Technical Evaluation Report

Draft Waste Incidental to Reprocessing
Evaluation for Closure of
Waste Management Area C,
Hanford Site, Washington

Final Report

U.S. Nuclear Regulatory Commission
Office of Nuclear Material Safety and Safeguards
Washington, DC 20555-0001

Figure 2-3 Distribution of Waste in Tank C-108 Following Modified Sluicing

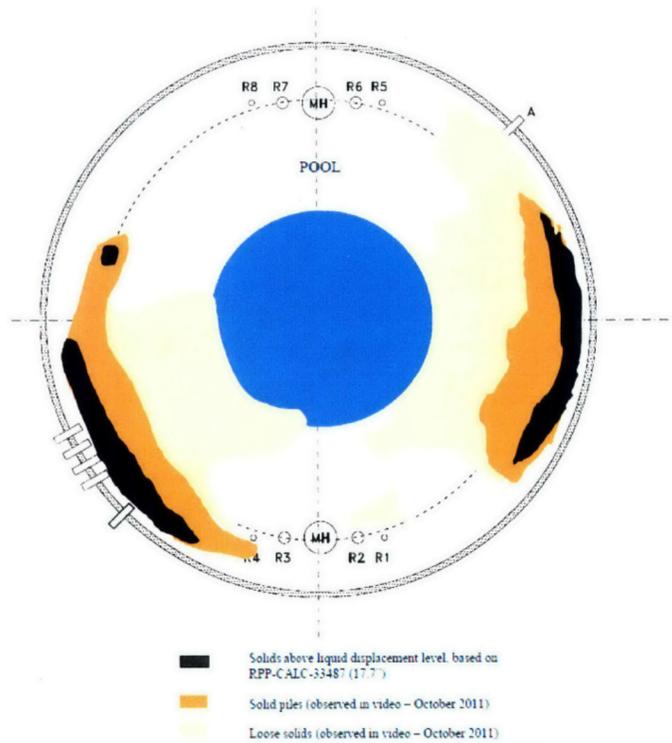
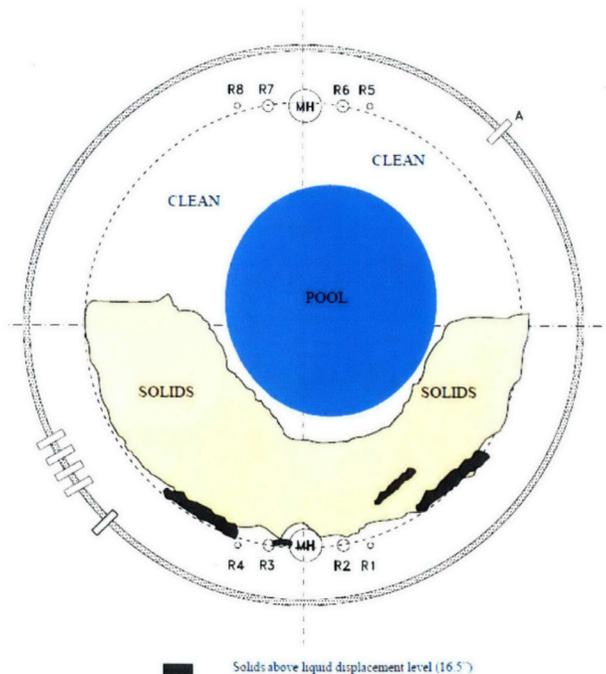
Figures 2-3 and 2-4 show the importance of the number of sluicers in a tank. When two sluicers were available in Tank C-108, the waste closest to the sluicers was removed, resulting in piles of waste on the periphery of the tank at the farthest distance from the sluicers. The motive force that can be applied to the waste to direct it to the pump for removal decreases with increasing distance. After one of those sluicers was plugged, the waste was redistributed to the half of the tank farthest from the operational sluicer. The residual waste in the tank was able to be moved around; however, the waste could not be removed using the technology employed. Similarly, for Tank C-110, DOE indicated in the Draft WIR Evaluation for WMA C that the waste could be mobilized with the sluicers but would settle and could not be easily retrieved with the existing installed equipment.

Figure 2-5 Hydroxide Concentration During Caustic Dissolution

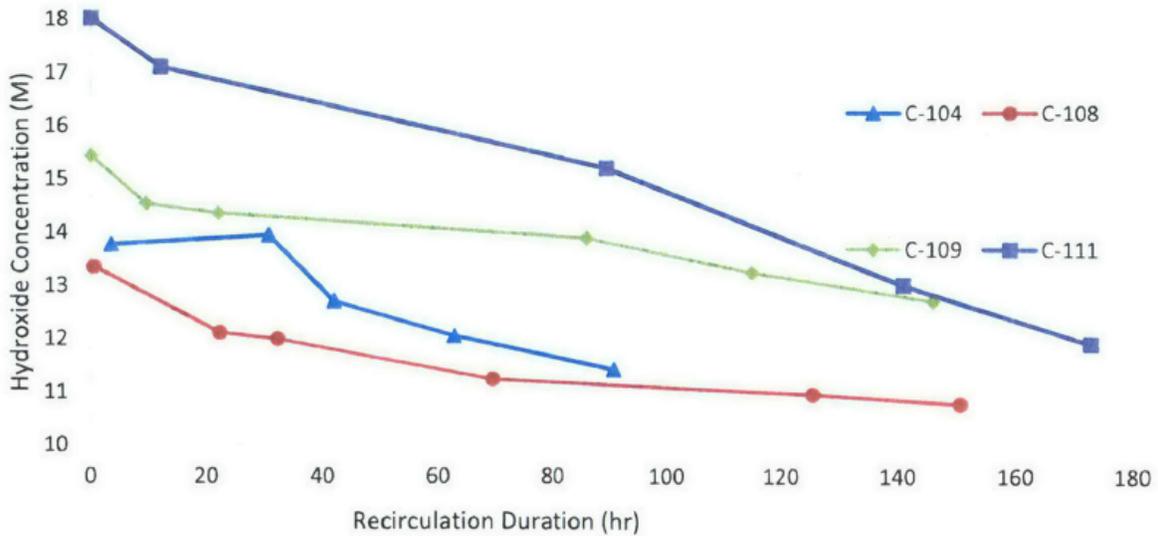
Figure 2-5 shows the hydroxide concentration during caustic dissolution in various WMA C tanks. Some of the decrease is a result of water additions, and not due to reaction with the waste. For example, DOE indicated in RPP-RPT-59363 Rev 00A (2016) that 2,260 gal (8.6 m³) of water was added to Tank C-111 during the caustic dissolution. Approximately half of the decrease in hydroxide concentrations are the result of the water additions.

experience in the tank deviated significantly. For example, the bulk waste in Tank C-111 was very difficult to remove with sluicing, whereas laboratory tests predicted that it would be able to be removed. Comparison of field observed results to the anticipated results based on laboratory testing may not always yield a robust basis for terminating retrieval activities, if the actual waste in the tank has different phases present or is in a different physical configuration and state such that the conditions for contacting reactants with the waste are different. If there is disagreement between field data and laboratory data, then the rate of change of the field data should be the primary input to the decision of when to terminate waste retrieval. The criteria for terminating retrieval of waste by chemical means should be adjusted based on field experience when field experience differs from laboratory experience (Recommendation #3).

Figure 3-6 Erosion at the Hanford Barrier from a Severe Thunderstorm

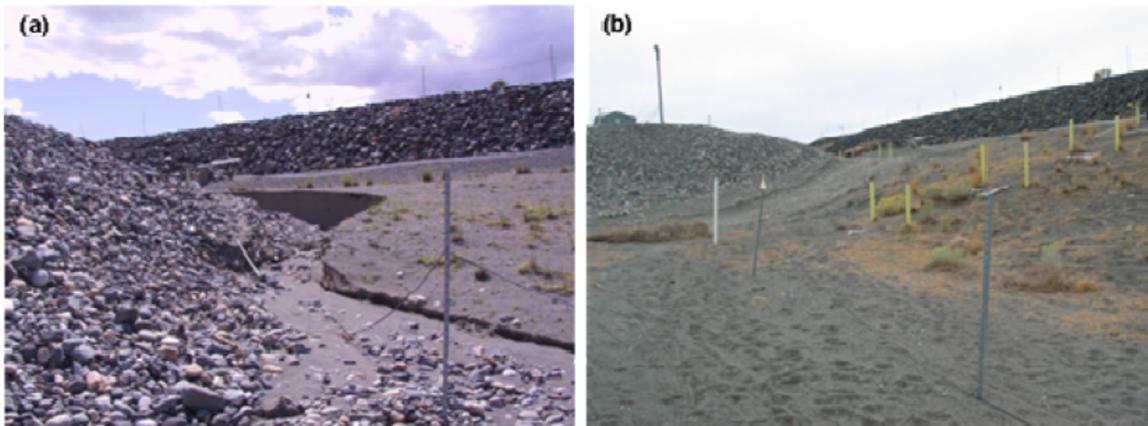
Field studies documented in PNNL-14143 (2002) involved one-half of the soil surface being irrigated for three years such that simulated precipitation averaged three times the long-term annual average (480 mm/yr or 19 in/yr). More intense rainfall representing a 1,000-year return storm for the Hanford Site was applied in March for three years (70 millimeters or 2.8 inches in 8 hours). After the first year of testing, there was no measurable wind erosion, and runoff was small and mainly associated with rapid snowmelt. The side slopes and soil cover remained stable. Limited erosion was attributed to extensive revegetation of the soil surface. Although the information from these field studies provide useful information, erosion protection designs must be based on an appropriately conservative rainfall event and that more rigorous analyses are required that include determining the Probable Maximum Precipitation (PMP) and designing a surface barrier for such an event. The PMP is defined as the theoretically greatest depth of precipitation that is possible during a given time period over a given area at a geographic location. The design criteria for the main component of the cover, the side slopes, and the toe of the side slopes should be similar to the methodologies and approaches found in the NRC's NUREG-1623 (2002), which addresses a 1,000-year timeframe. Therefore, the NRC staff recommends that for the final Waste Evaluation for WMA C, the design criteria for the main component of the cover, the side slopes, and the toe of the side slopes should consider the methodologies and approaches found in NRC's NUREG-1623 (2002), or DOE should develop guidance on long-term erosion protection design (Recommendation #16).

Water erosion has occurred on the Hanford Prototype Barrier as shown in photos from Section 2.2.4 in PNNL-17176 (2007) (shown in Figure 3-6). Severe thunderstorms with sufficient intensity to allow water to collect near the BY Farm eroded a berm, flowed down the northwestern slope of that tank farm, and eroded gravel armor and created a channel over 1 meter (40 inches) deep at the base of the barrier side slope. DOE has emphasized that the erosion was due to runoff from the BY-Tank Farm and not from the cover itself (NRC, 2018d). This episode, however, emphasizes the need for an engineered cover design in line with a PMP analysis. Alternatively, less performance credit for the engineered cover could be prescribed consistent with the expected rates of erosion of a less robust engineered cover design.

Figure 3-8 Engineered Structure at the Base of the C-100-Series Tank
 [Figure 6-7 in the WMA C PA (2016)]

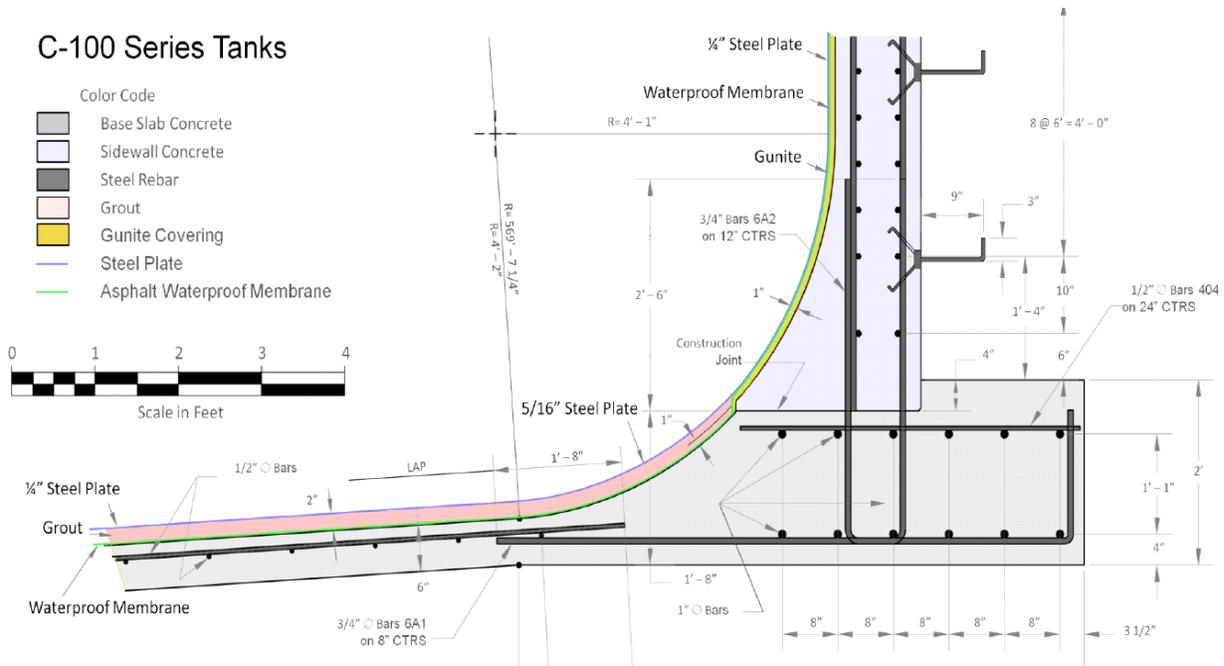
Both the 100-series and the 200-series tanks include steel protrusions from the tank walls into the surrounding soils (see Figure 3-8) that are not surrounded by a protective layer of concrete. Any corrosion of these protrusions outside of the concrete walls would continue to corrode along the rebar and into the concrete walls itself. DOE has stated that corrosion of the protruding steel would be evaluated further during closure (NRC, 2018d).

Figure 3-11 Flow Rate Transient and Flow Field Views at 1,000 Years for the 46-meter (150-foot) Diameter Saltstone Disposal Units
 [Figure DSP-6.6 in SRR-CWDA-2014-00099 (2015)]

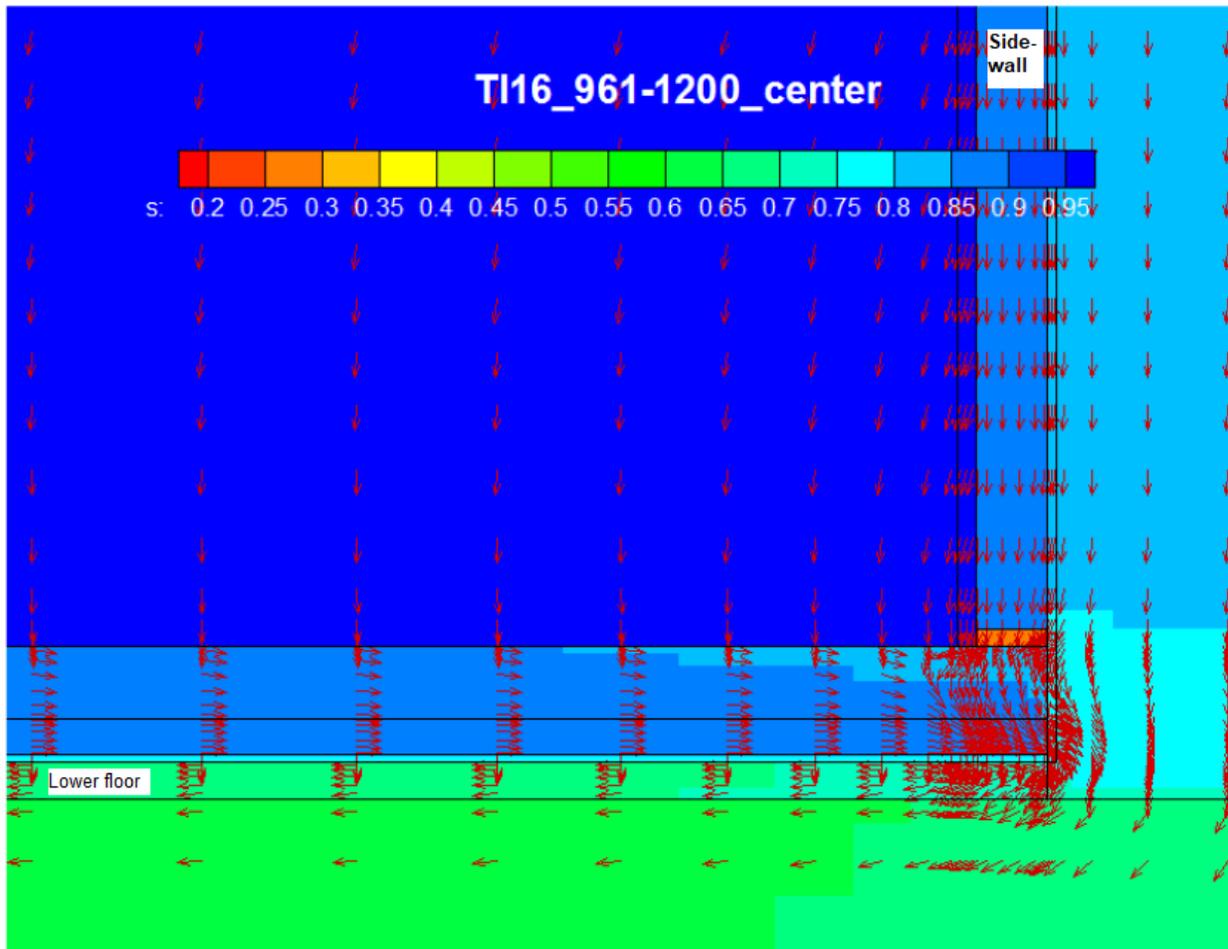
Based on the degradation rates shown in Table 3-4, modeling results at 1,000 years were presented in Figure DSP-6.6 in SRR-CWDA-2014-00099 (2105). Figure 3-11 reproduces the lower right corner of the disposal unit from that figure and presents the volumetric flow rate for the selected grid zone. The vault wall is a preferred flow pathway in comparison to the cementitious mortar (i.e., Saltstone) and the lower mud mat (i.e., lower floor layer) is carrying water towards the middle of the vault.

There are differences between the two sites, the disposal facilities, and the disposal of the waste. For example, the saturated hydraulic conductivity value of the undegraded Saltstone (6.4×10^{-9} cm/sec [2.5×10^{-9} in/sec]) allows some water to flow through the wastefrom while no water is assumed to flow through the intact infill grout at WMA C (Page 6-28 in DOE, 2016). In addition, the gravel-containing backfill at WMA C has a higher hydraulic conductivity than the soils surrounding the Saltstone disposal units.

Figure 3-18 Comparison of HDW 5.0 Radionuclide Concentrations in Sludge with Results from Sampling

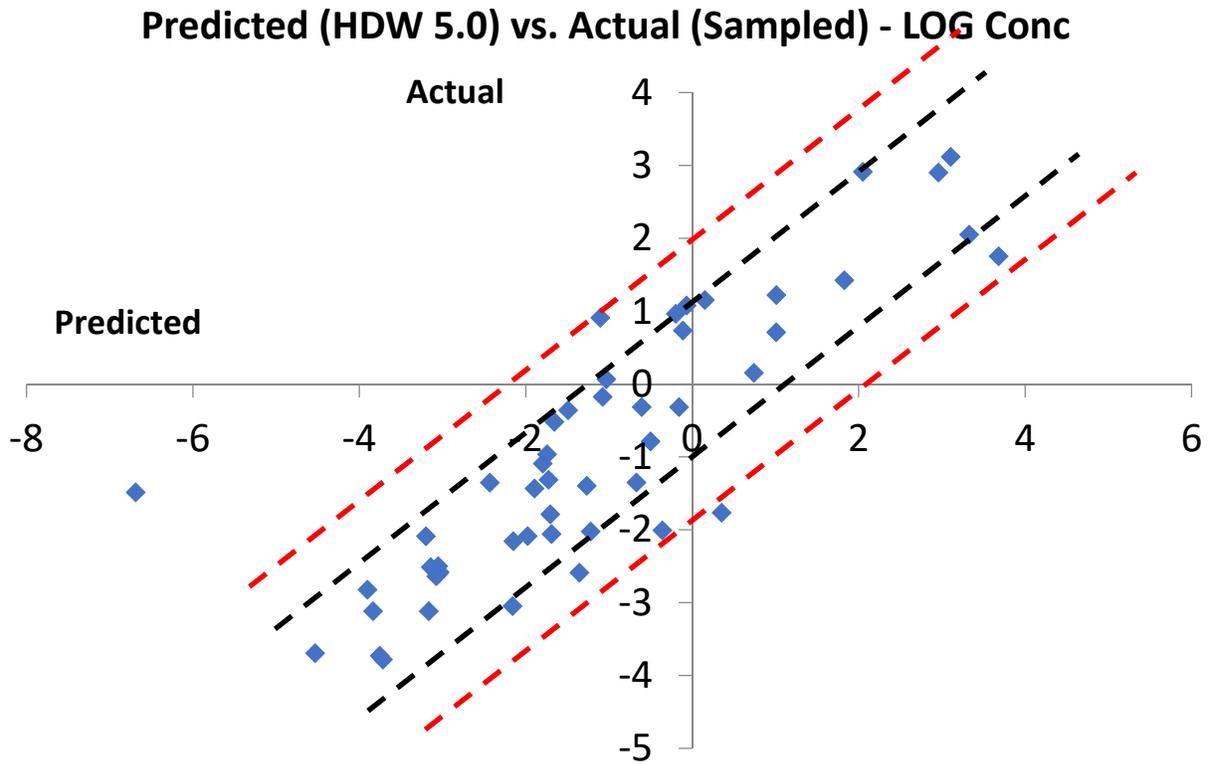
The HDW model was used for many of the radionuclide inventories found in the BBI (RPP-19822). Staff reviewed the HDW model to understand how it works and if the inventory estimates are reliable. Staff requested the spreadsheets and background documents from DOE. Figure 3-18 provides a comparison of the predicted sludge concentrations from HDW 5.0, with the actual sample concentrations for select risk-significant radionuclides.

DOE did not clearly distinguish which radionuclide inventory results were based on sampling and which were based on other methods such as modeling or process knowledge. It is recommended in future waste determinations that DOE provide more transparency as to the source of the inventory information such that the assigned uncertainty ranges can be better understood and evaluated (Recommendation #24).

Figure 3-23 Estimates for Saturated Horizontal Hydraulic Conductivity Based on Slug Tests, Pump Tests, and Model Calibration
 [Figure C-6 in the WMA C PA (2016)]

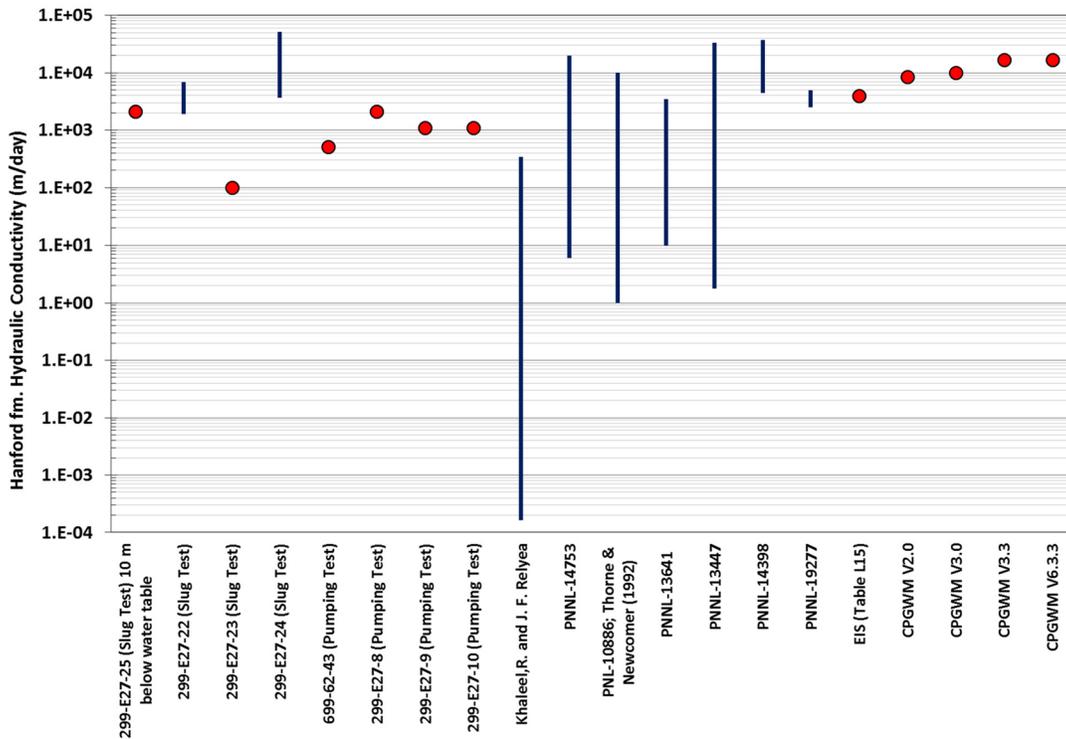
As shown in Figure 3-23, until recently, most DOE documents provided a range of hydraulic conductivity values that were lower than the current average WMA C PA value of 11,000 m/d (36,000 ft/d). Previously, in RPP-RPT-46088, Revision 1 (2010), DOE had given the general range of saturated hydraulic conductivity values for the unconfined aquifer as between 1,000 to 3,000 m/d (3,300 to 9,800 ft/d), with a recommended parameter value of 3,000 m/d (9,800 ft/d) and a recommended minimum and maximum of 100 m/d (330 ft/d) and 7,000 m/d (23,000 ft/d), respectively. The general range of hydraulic gradient values recommended for the unconfined aquifer was 1×10^{-5} m/m, with a recommended minimum and maximum of 2×10^{-6} and 1×10^{-4} m/m, respectively. This would provide an overall flow velocity or flux uncertainty range of 0.0002 m/d (0.0007 ft/d) to 0.7 m/d (2 ft/d). Even as recently as the “WMA C PA Mid-Year Status Working Session” in June 2014 (DOE, 2014), DOE listed the above hydraulic values as the hydraulic properties of the aquifer for the WMA C STOMP model.
